Memorandum

TO: Planning and Environmental Commission

SUBJECT: A request for a final review of a minor exterior alteration or modification, pursuant to Section 12-7B-7, Exterior Alterations or Modifications, Vail Town Code, to allow for a revised entrance, located at 231 East Gore Creek Drive / Lot A, Block 5B, Vail Village Filing 1, and setting forth details in regard thereto. (PEC16-0011)

Applicant: Gasthof Gramshammer, Inc. / Pepi's Restaurant, represented by
Russell J. Gies, Gies Architects, Inc.

PROPOSED LANDSCAPE AREA TO BE ADDED:
LANDSCAPE AREA #6: 25 SQ. FT.
LANDSCAPE AREA #7: 90 SQ. FT.
PLANTS:
COLORED TULIP (TULIPA BAKERI, CLUSIANA, CHRYSANTHA, HAGERI, HUMILIS)
SIZE: 4"-14"
QTY: 25 BULBS
TREES:
DWARF BLUE SPRUCE
SIZE: 3'-4'
QTY: 4 TREES

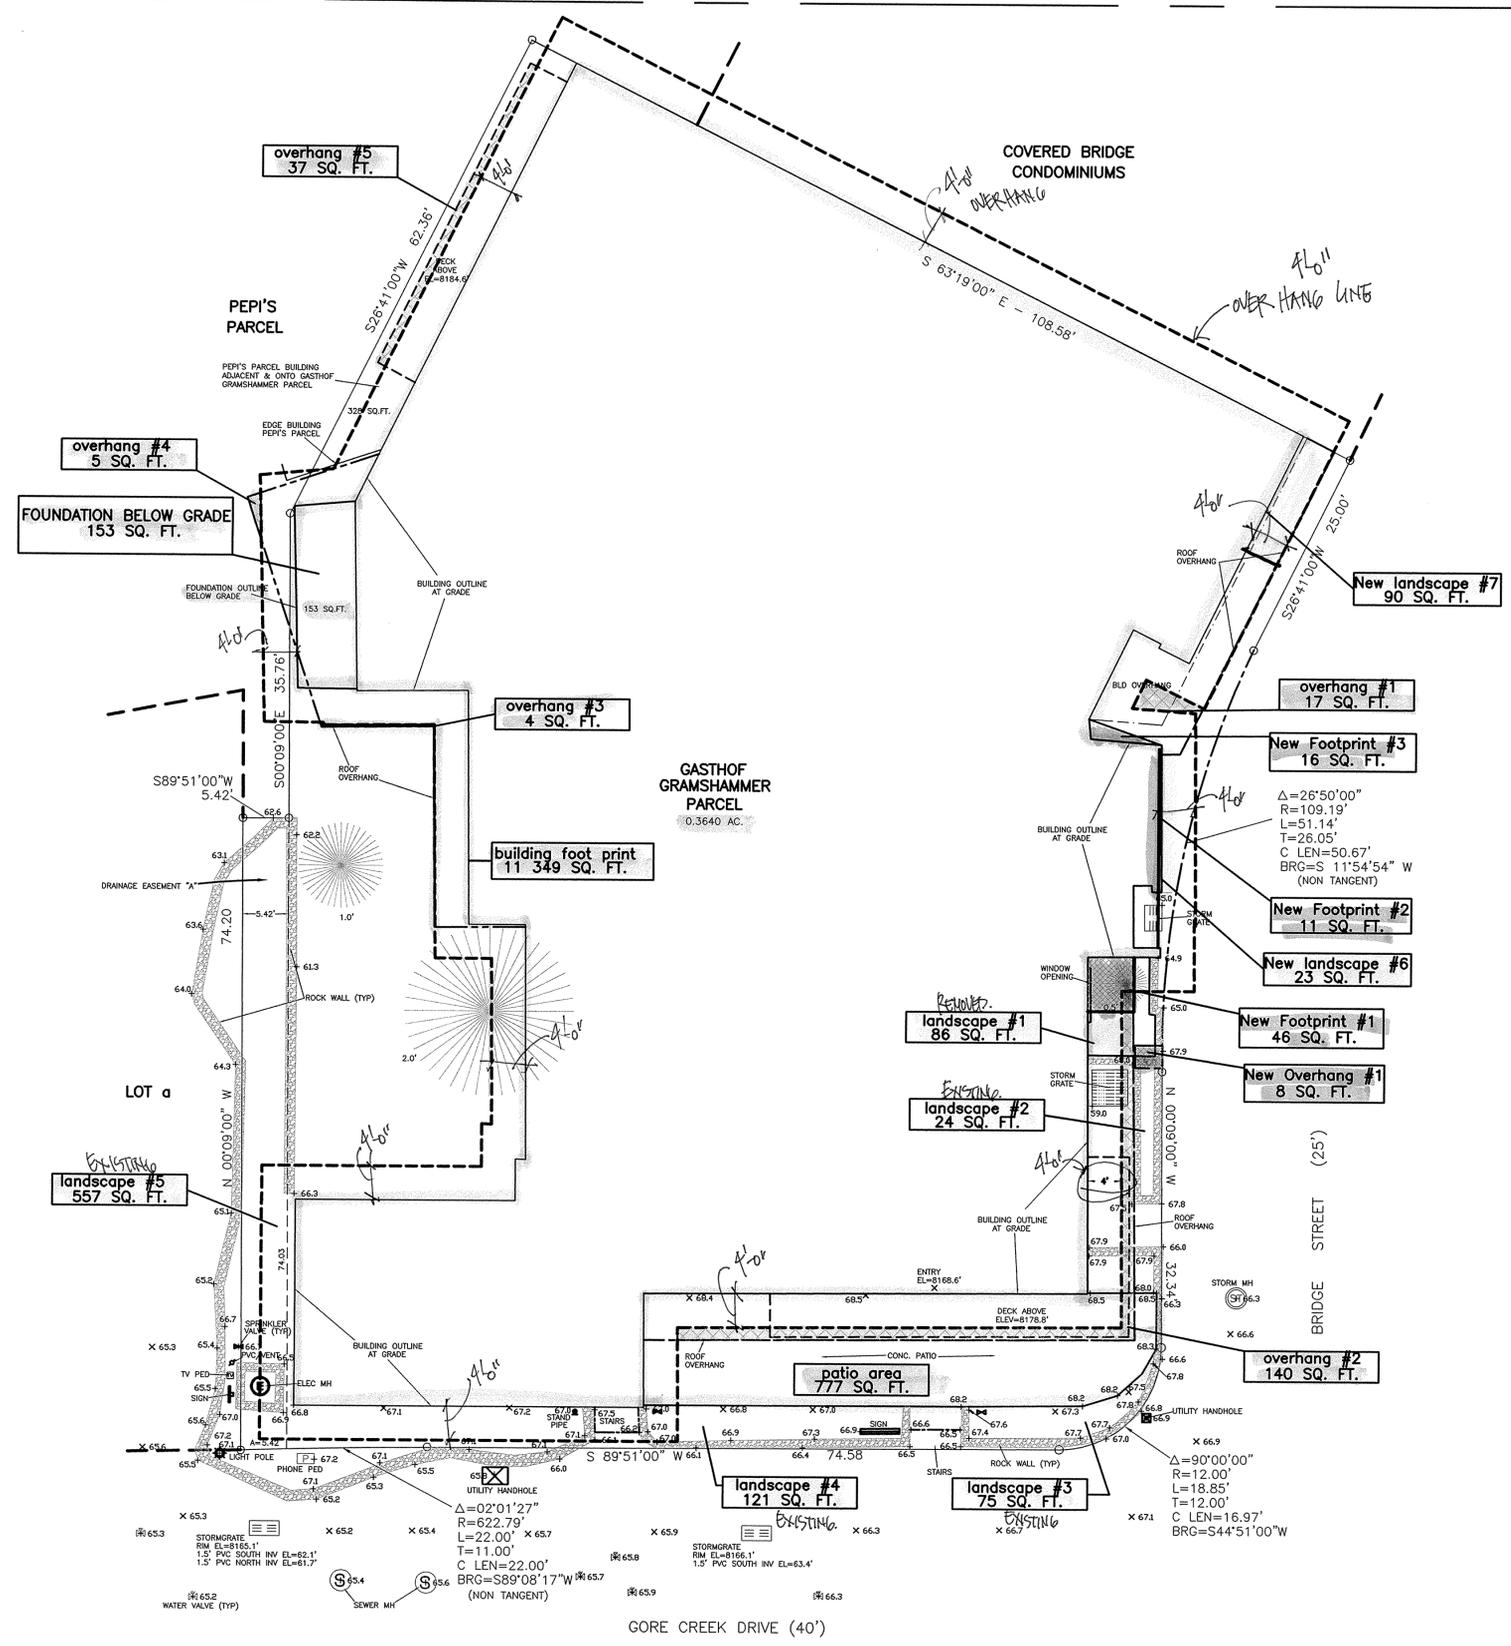
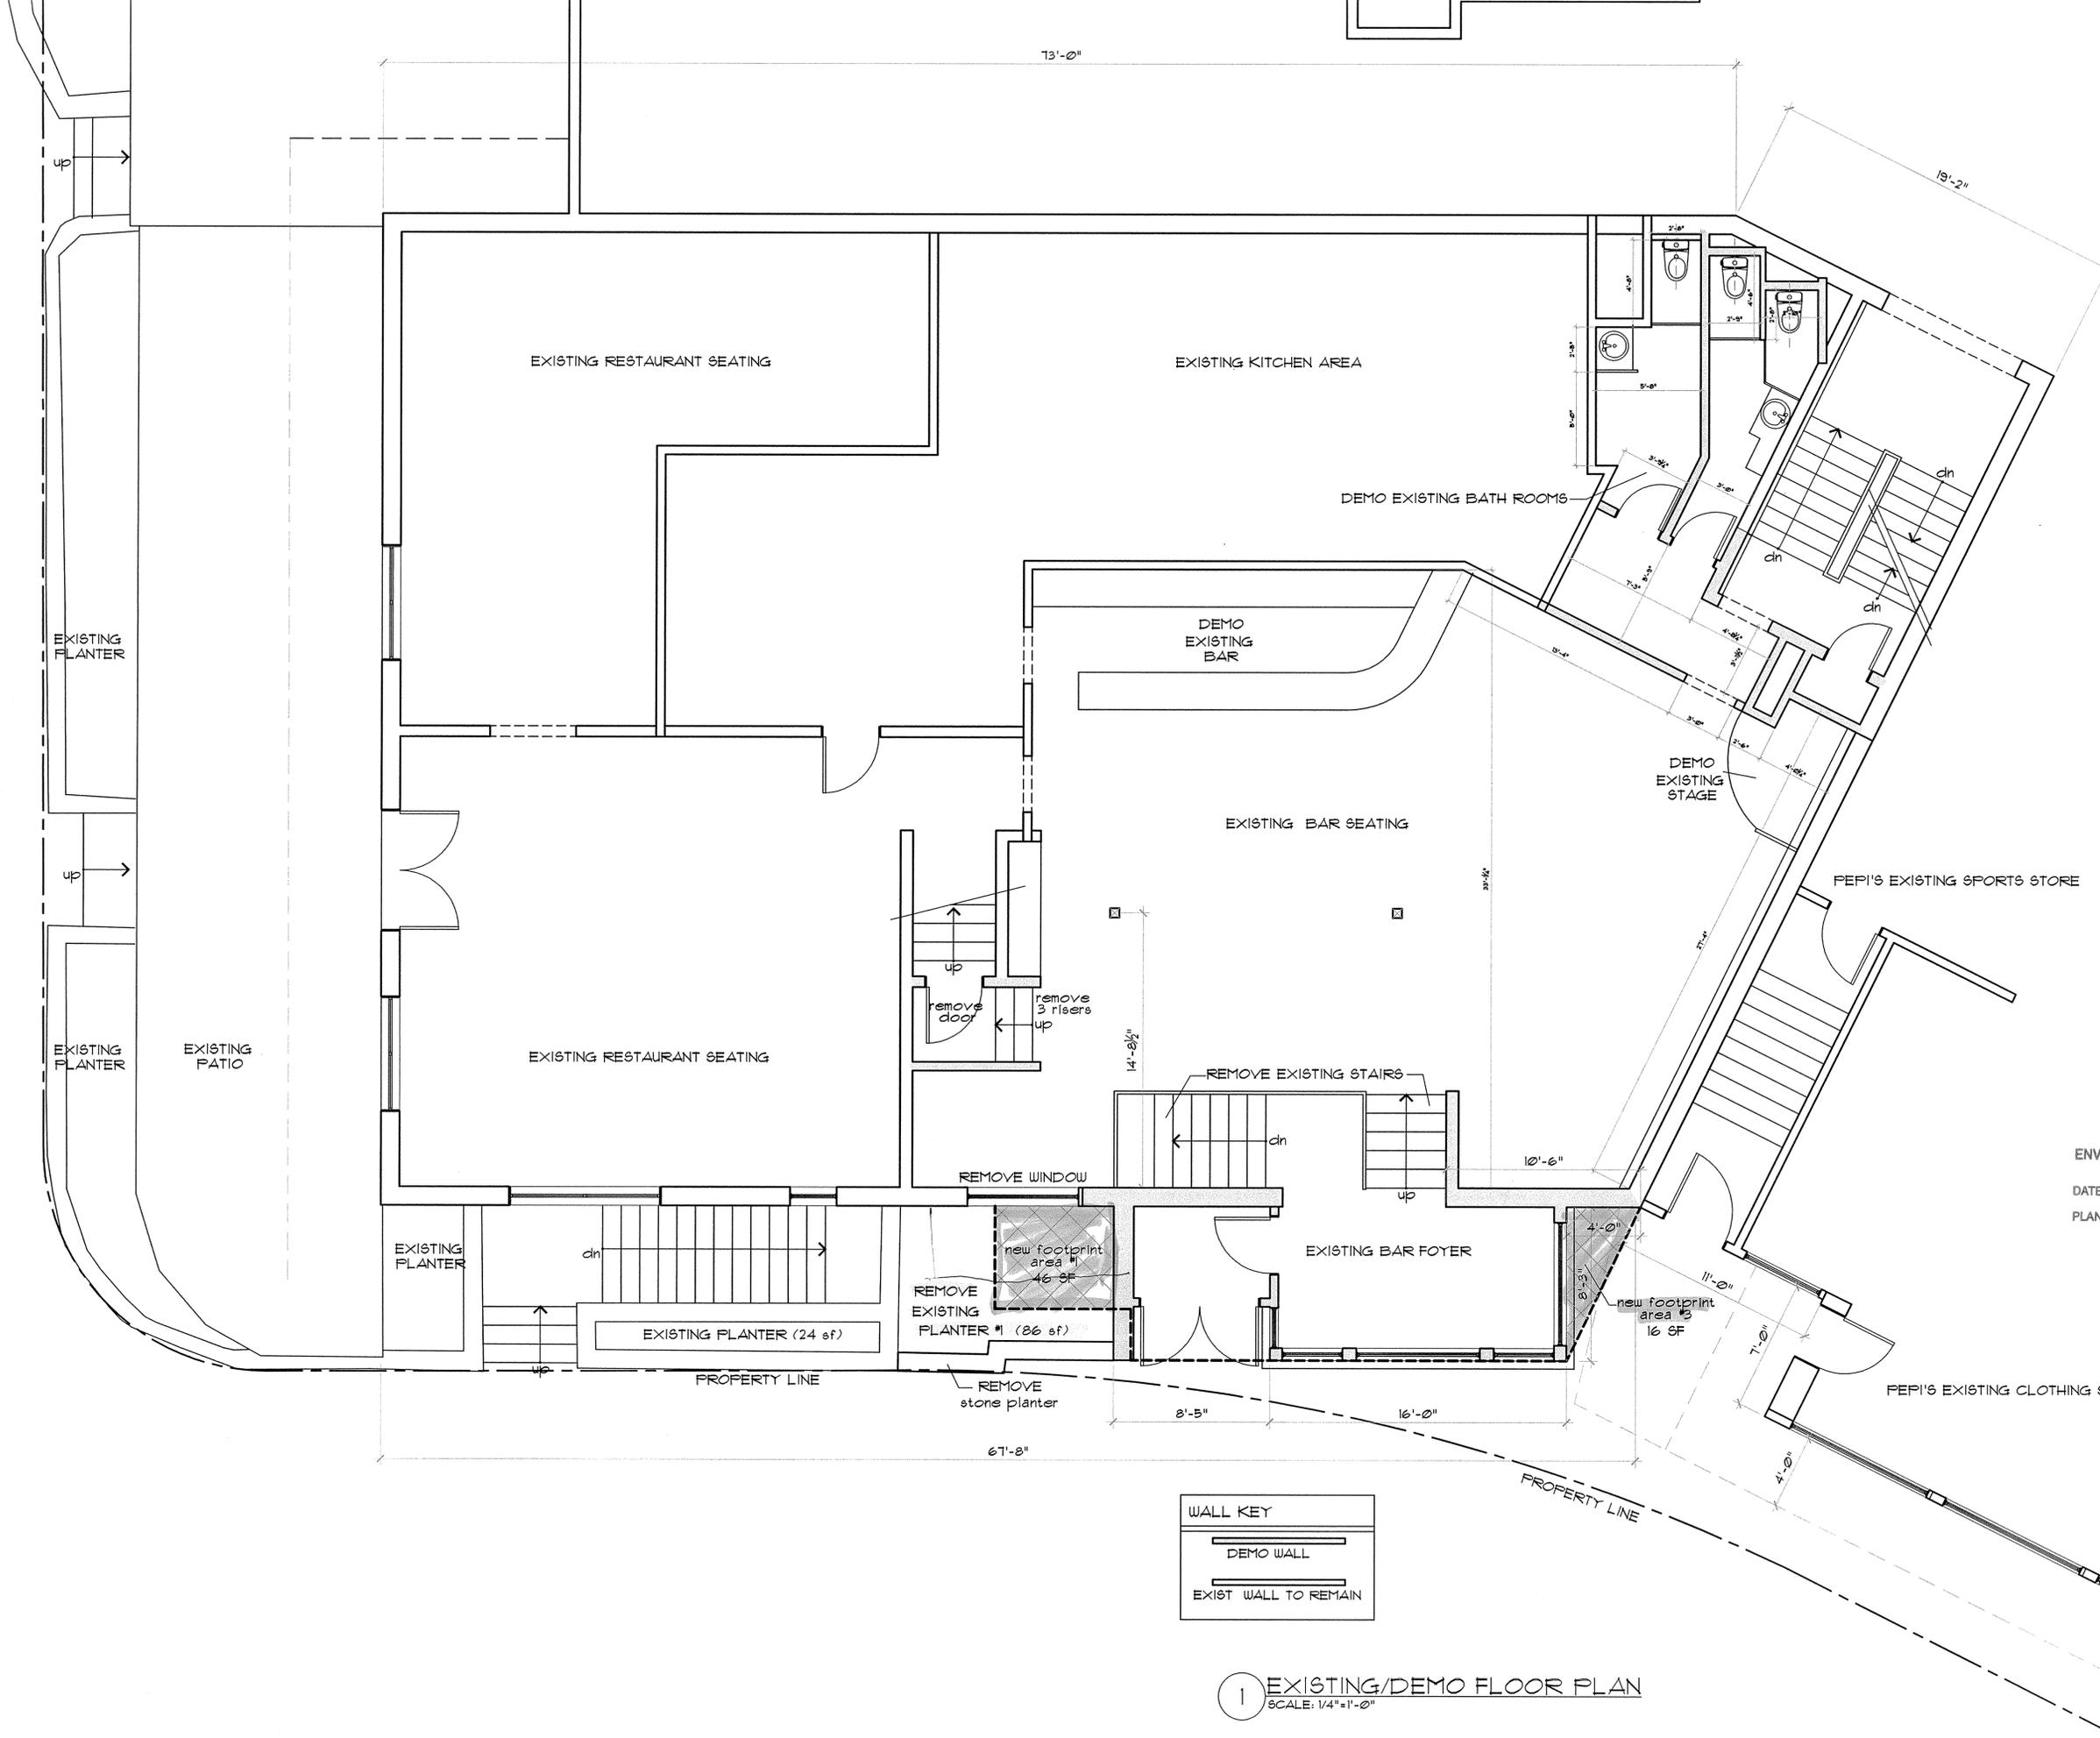
Landscaping modifications will result in a net increase of twenty-four (24) square feet of landscape area, primarily through the removal of the existing landscape area near the entrance and the addition of a new stone planter at the base of the new windows and at the northeast corner of the site.

Stockmar – Planter will not go into the right of way?

Gies – Landscaping planter will be on private property.

PROJECT: PEP'S BAR REMODEL
231 E. Gore Creek Dr. - Vail, CO.
DRAWING: EXISTING AND PROPOSED ELEVATIONS

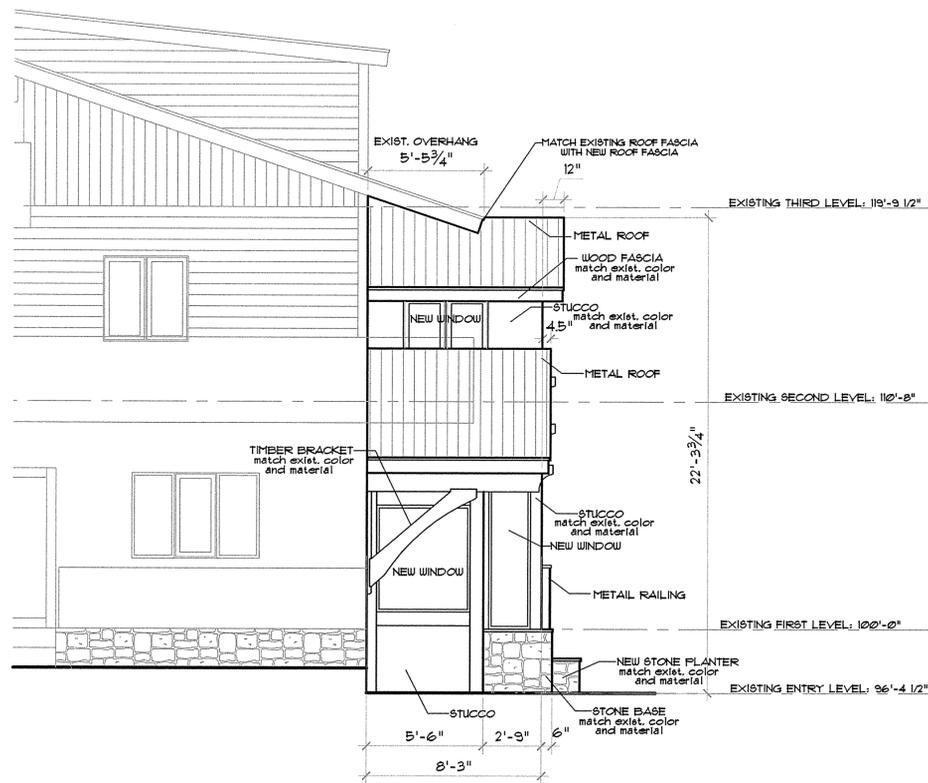
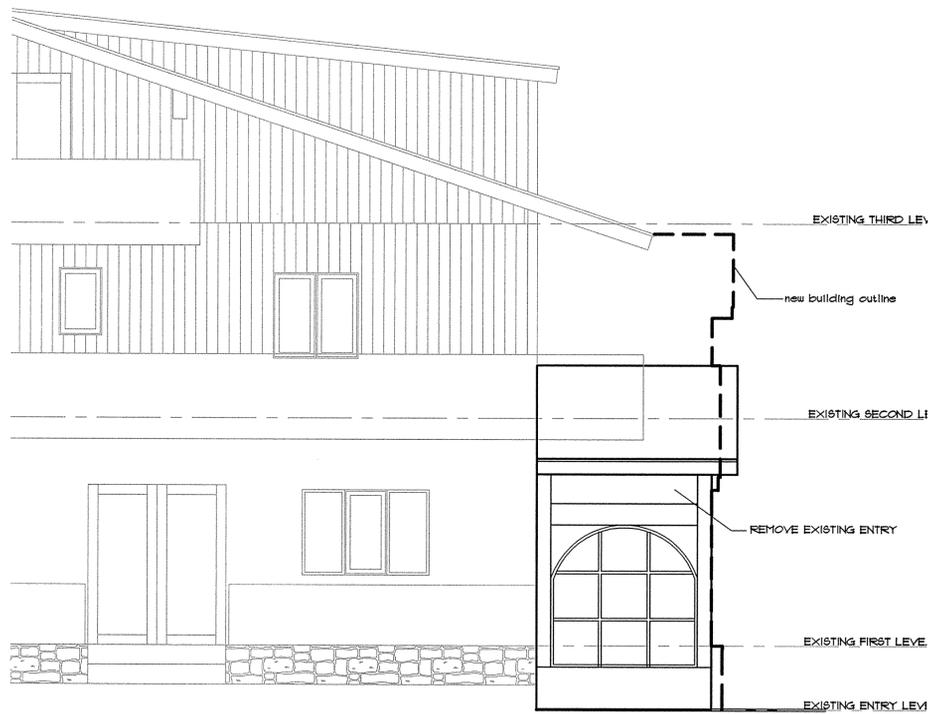
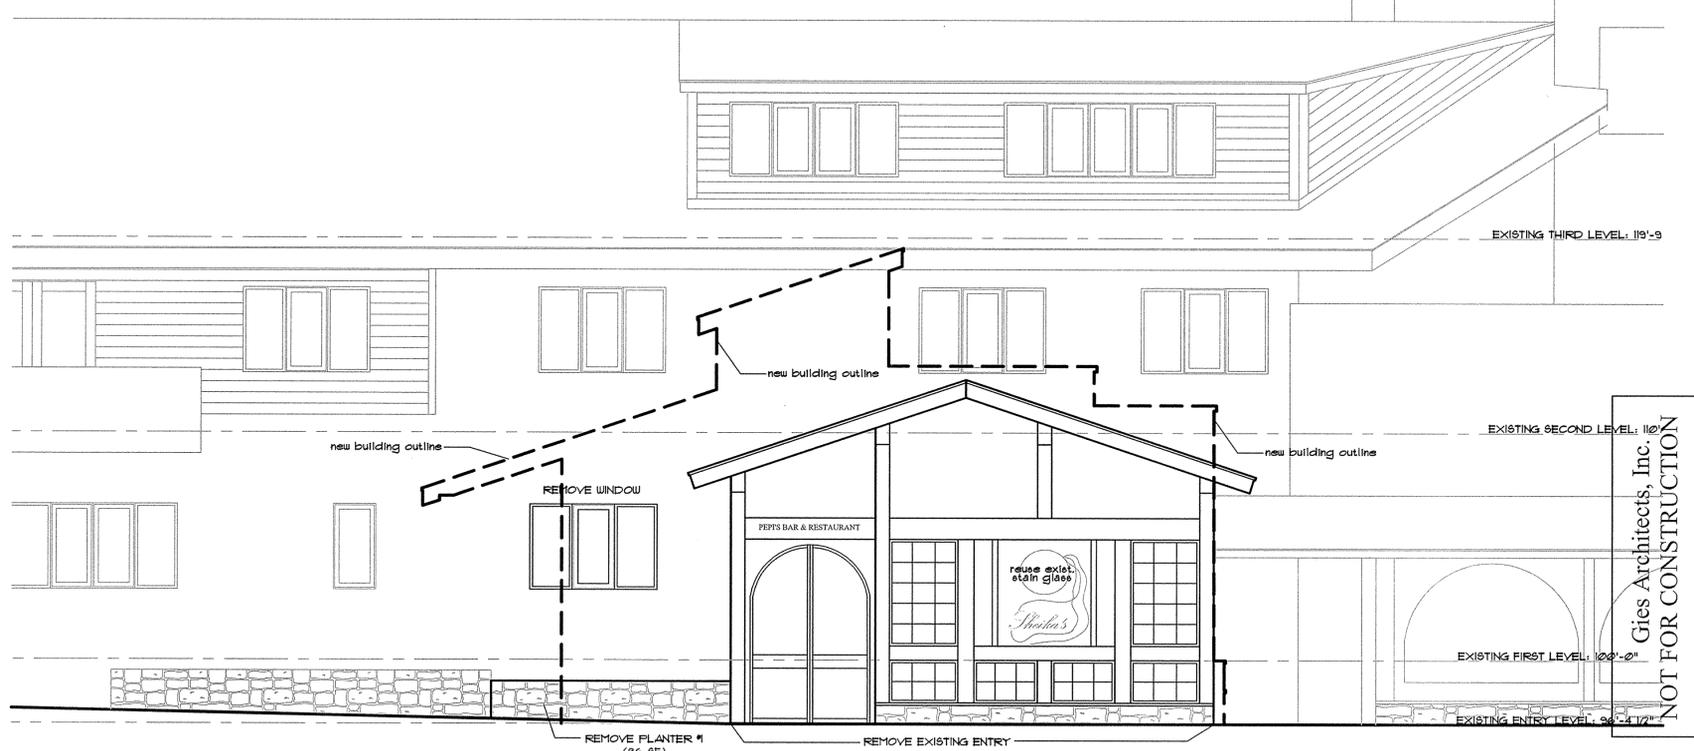
The proposed windows will have fewer mullions and muntins (glass dividers) than the existing windows; however, the proposed windows will slide to allow for an open-air connection to the pedestrian environment. The existing stained glass window will be relocated from the first floor to the second floor and maintains an element of uniqueness to the entrance.

The proposed revised entrance is consistent with the existing structure, and surrounding structures, in scale and massing. Materials and colors will match the existing conditions. Also, the reuse of the existing stained glass window will help blend the new entrance with its iconic history.

The proposed revised entrance is consistent with Concept 18 within the Gore Creek Drive / Bridge Street section of the Vail Village Urban Design Guide Plan which advocates, "Façade improvements. Increased ground floor transparency."

Hansen – Support project as well. If you wanted to change the whole side of the building, it would not be OK. But for a section of all 18 feet long, it works. This space needs to be fixed. Good design, I support it.
